# United States Department of the Interior

### MEMORANDUM

**Subject:** Inspection of Fishways at Conowingo Hydroelectric Project (FERC #405) on May 7, 2015

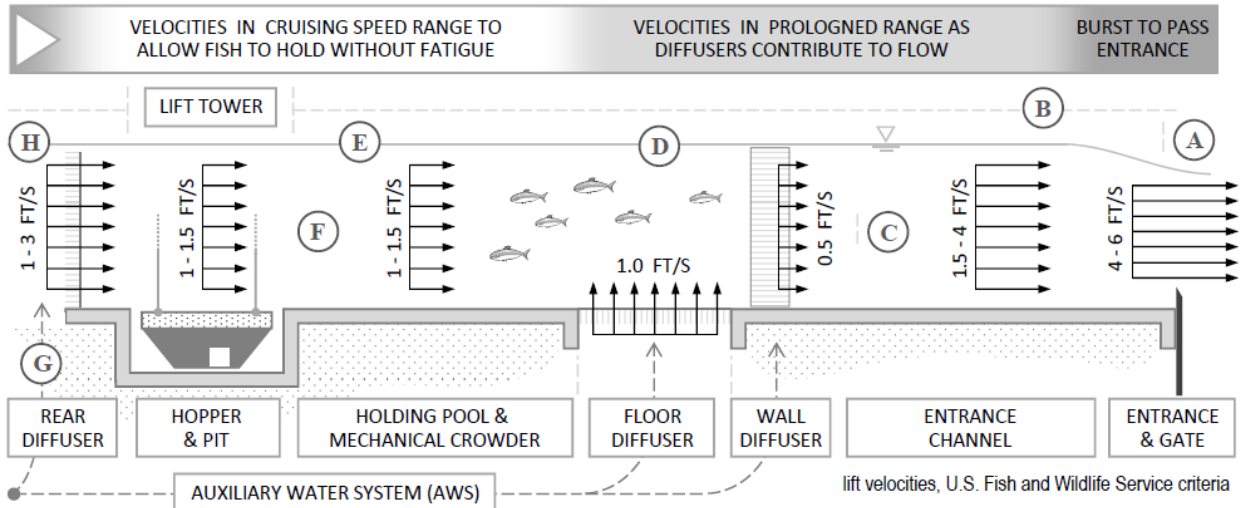
- Attraction flows - The EFL attraction water is fed through the western-most spillway bay. A significant fraction of this flow is passed down the ogee crest, through a stilling basin and into the entrance channel. The stilling basin is still not capable of dissipating enough energy to effectively allow the discharge of the original design flow (i.e., 900 cfs). The aeration and turbulence observed have been shown to dissuade shad movement. Discussions with Exelon's operators suggest that the current entrance channel design is incapable of passing more than 300 cfs without significant turbulence and aeration. Delays and ineffective passage due to insufficient attraction water are a concern.
